Technical Service Bulletin

40 Front shock absorber cap, cracking noises/spring jumps when steering or when maneuvering

40 23 59 2047758/10 June 6, 2023. Supersedes Technical Service Bulletin Group 40 number 23-57 dated May 24, 2023, for reasons listed below.

Figure 1. Shock absorber and buffer stop.

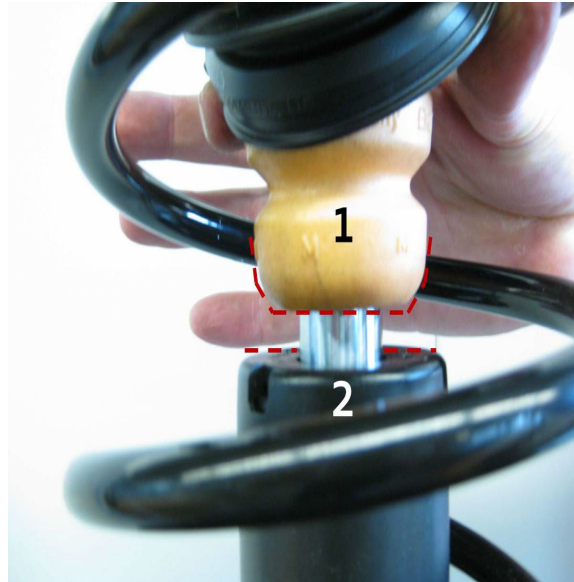
The buffer stop for the shock absorber (Figure 1, 1) can cause noises if it touches the front shock absorber cap (Figure 1, 2).

Lightly lubricate the contact surface (red dotted line) between buffer stop for shock absorber (Figure 1, 1) and front shock absorber cap (Figure 1, 2) with 5 grams grease G 000 405 A2 per side.
